Subject: AP1000 COL Standard Technical Report Submittal of APP-GW-GLN-019, Revision 2 (TR 103)

The changes within this Technical Report are a compilation of approved design changes to AP1000 Fluid Systems that have not previously been submitted under individual header. This document is sectioned to identify Fluid System changes that have been approved by the Westinghouse Change Control Board, that have not been submitted in previous Technical Reports, and that have had a direct impact on the Design Control Document (DCD). These are predominantly minor changes in system designs that are due to the progression of the detailed design. Each change will be individually identified within this document. The description of these changes can be found within Section II of this document. Additionally, not all of the changes described within this document have been incorporated into Rev. 16 of the AP1000 Design Control Document. The changes to R16 are detailed on pages 144 to 149.

Title: Fluid System Changes

Figure 5.1-1

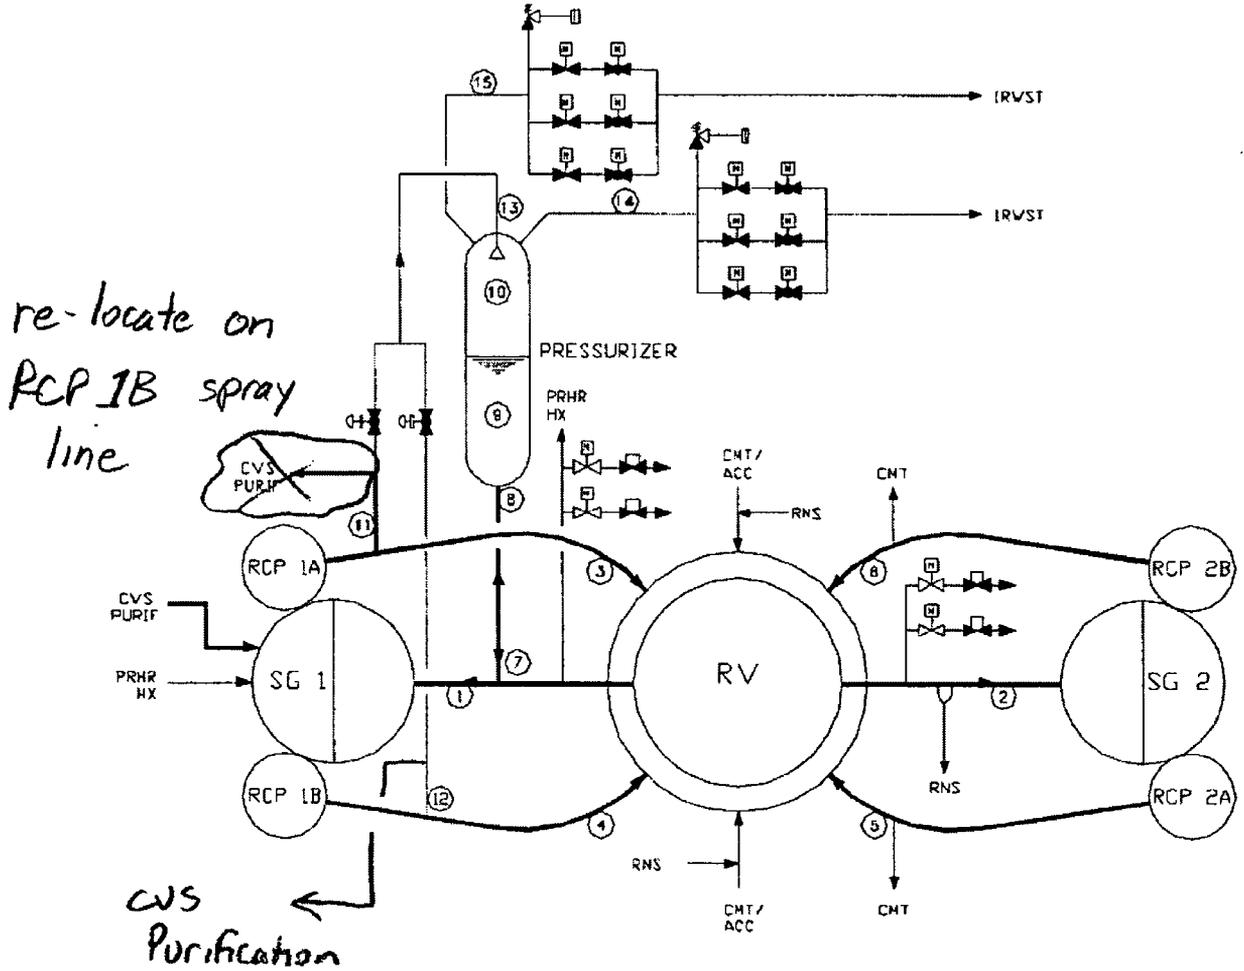
1. DCD Figure 5.1-1 (a simplified sketch of the RCS) incorrectly showed that the CVS purification system originates from cold leg 1A; it has been corrected to show that it originates from cold leg 1B.

Figure 5.1-5 (Sheet 1 of 3)
 Inside Reactor Containment

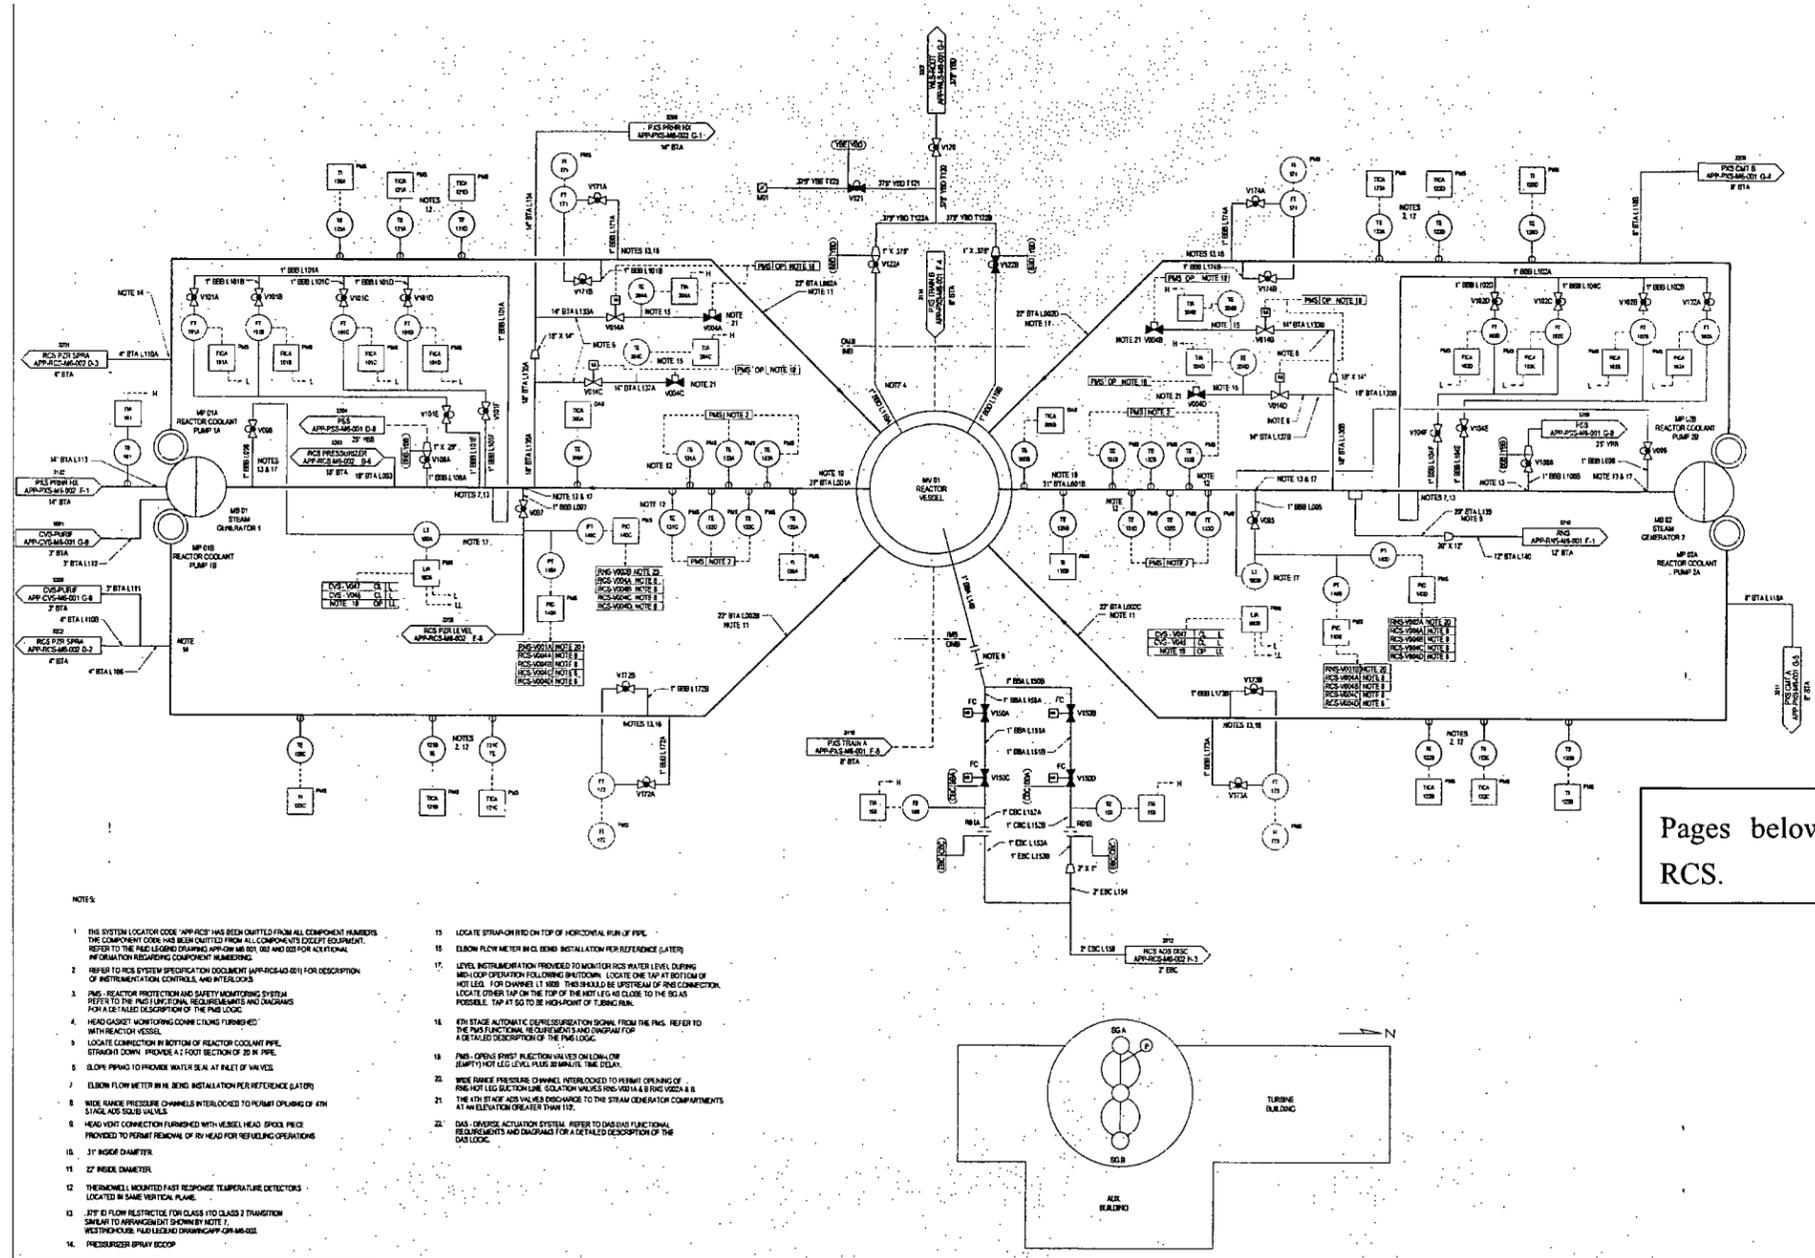
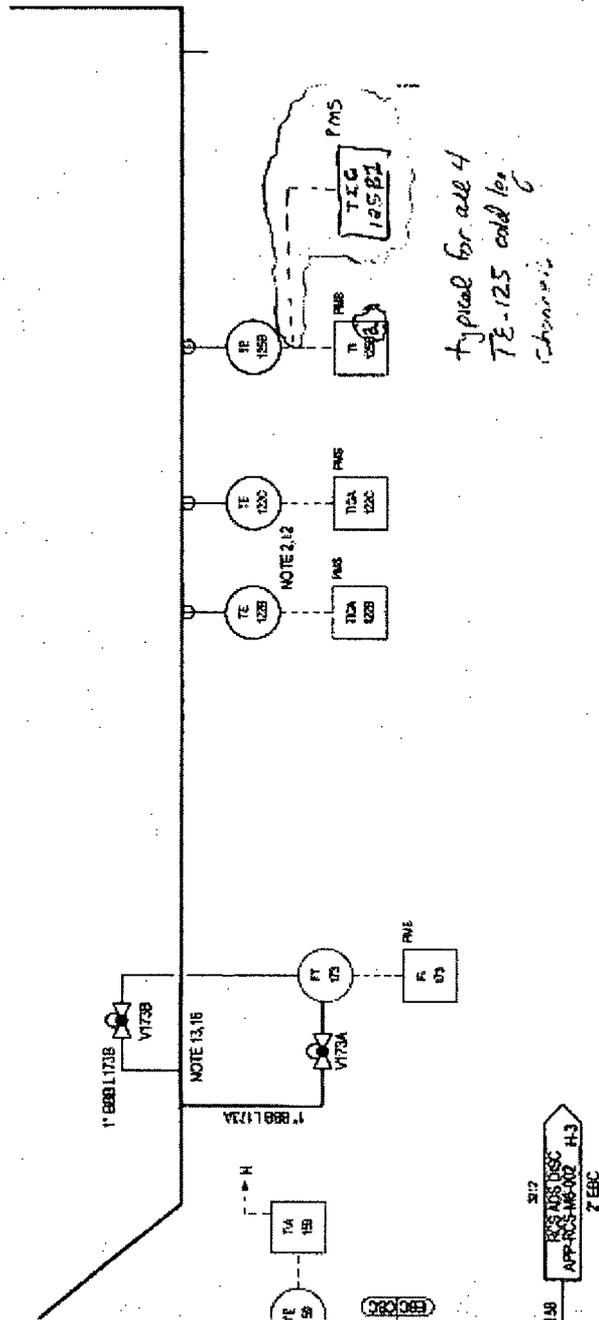
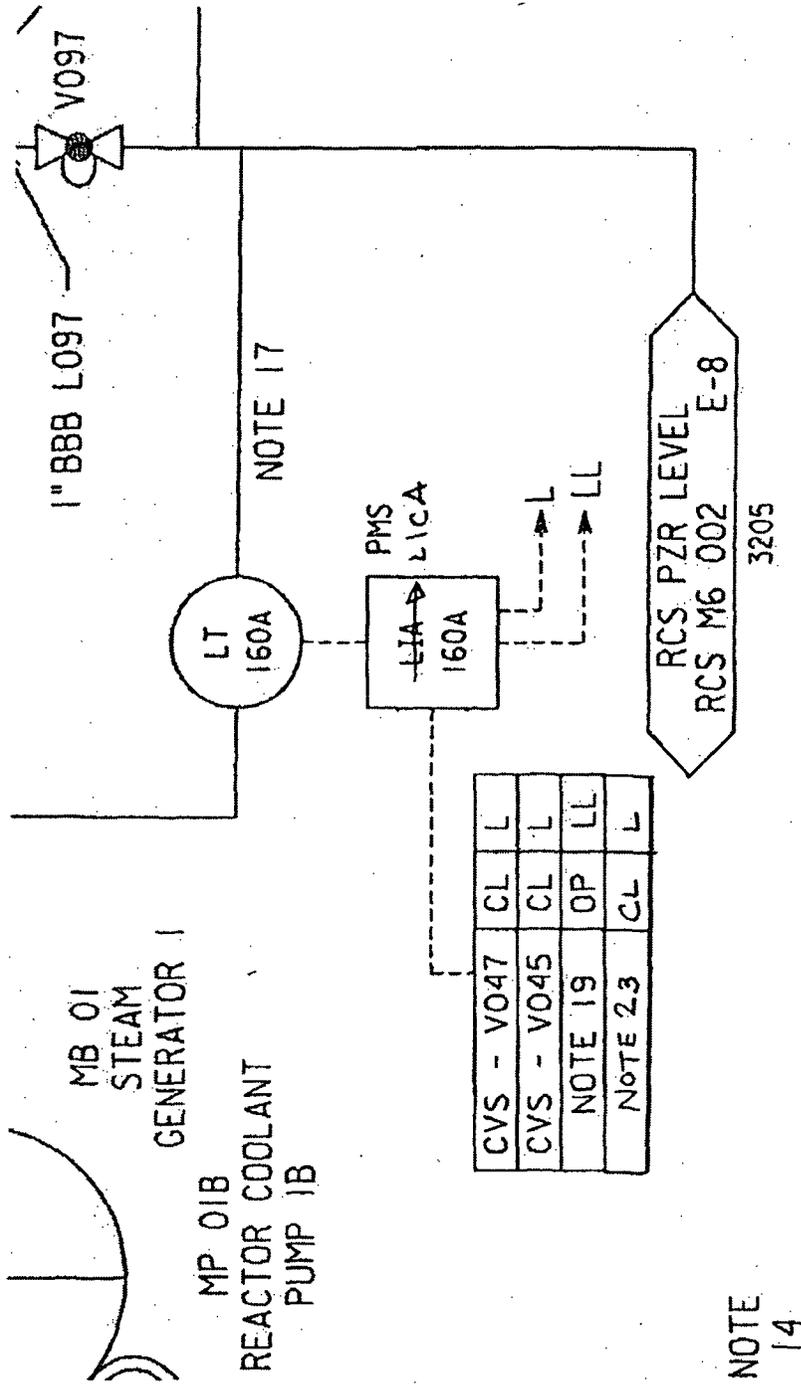
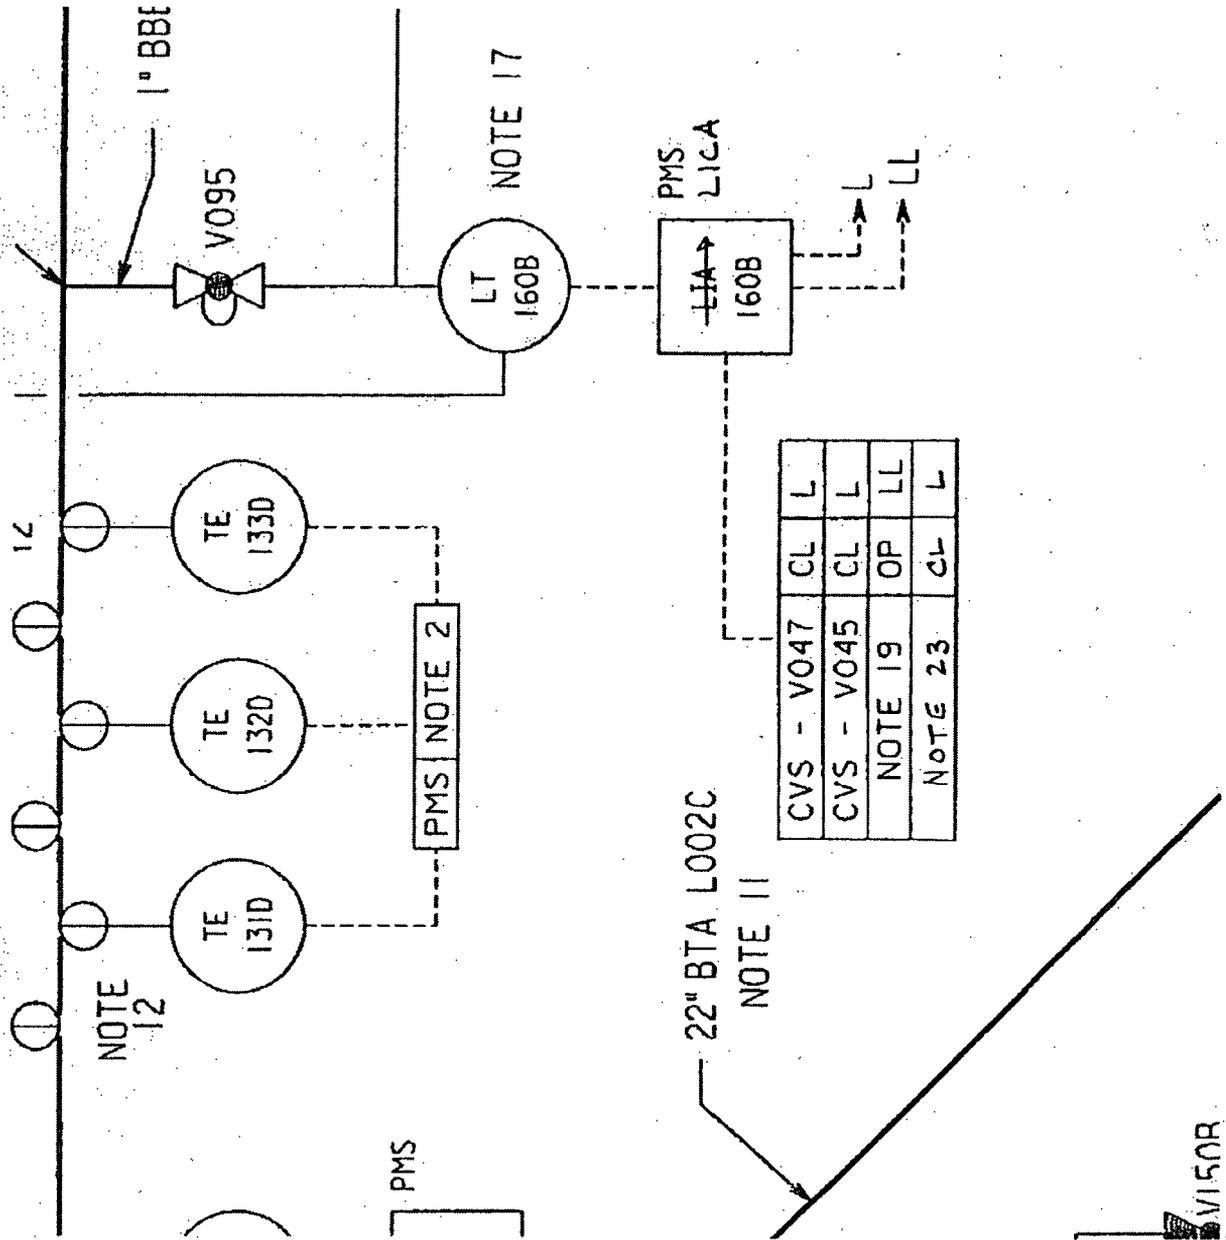
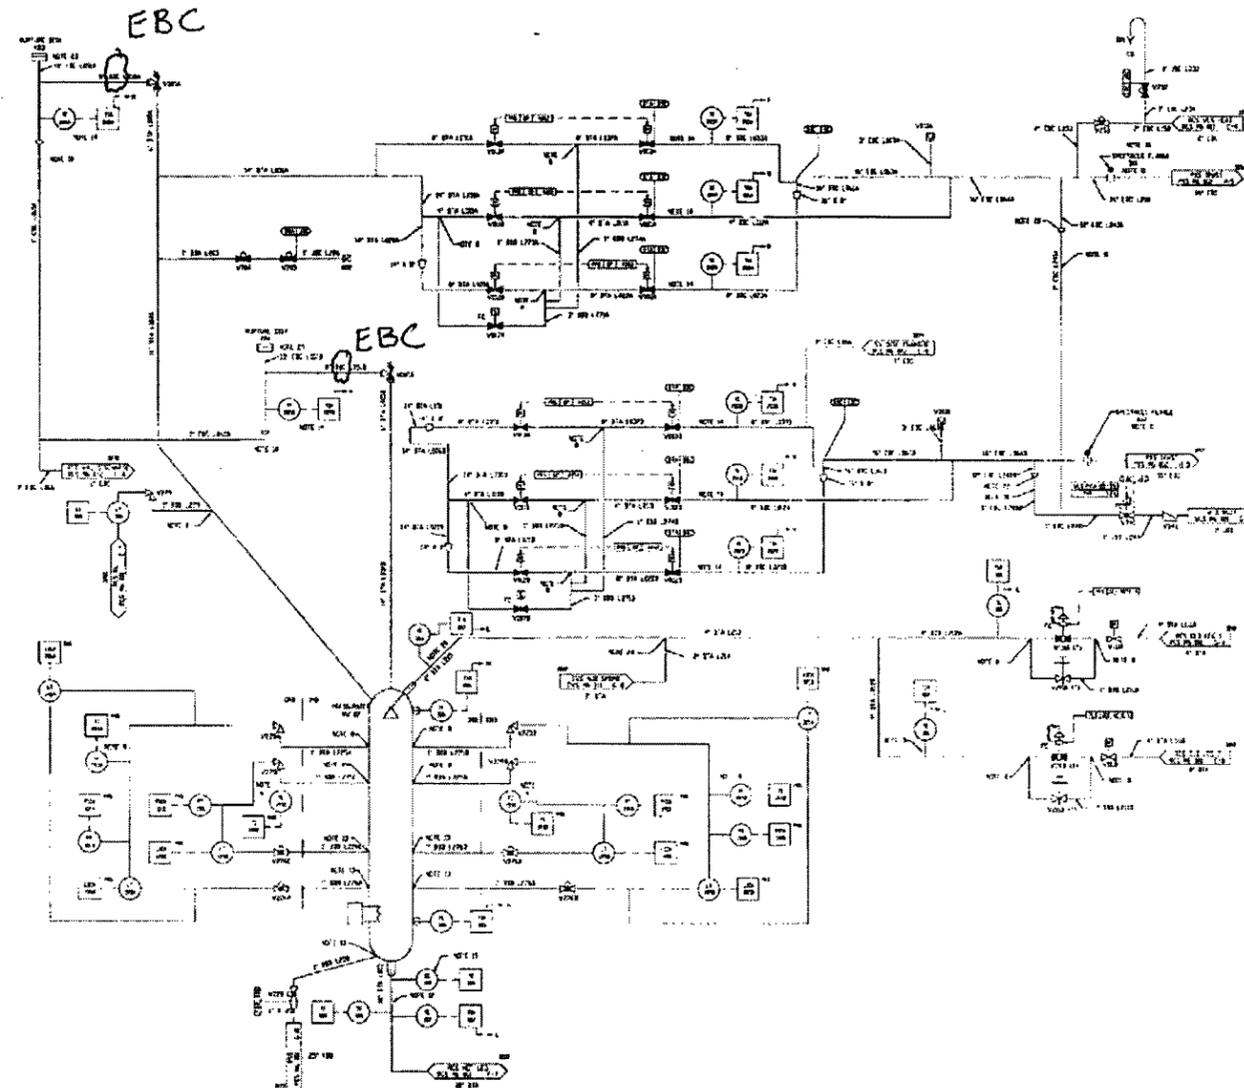
In order to properly define the functional requirements for the dual temperature range channels RCS-TE125 A, B, C, D, the I&C systems require the establishment of separate I&C and P&ID database identifiers for each range of RCS-TE125 A, B, C, D this change is shown in the markup of Figure 5.1-5 (Sheet 1 of 3).
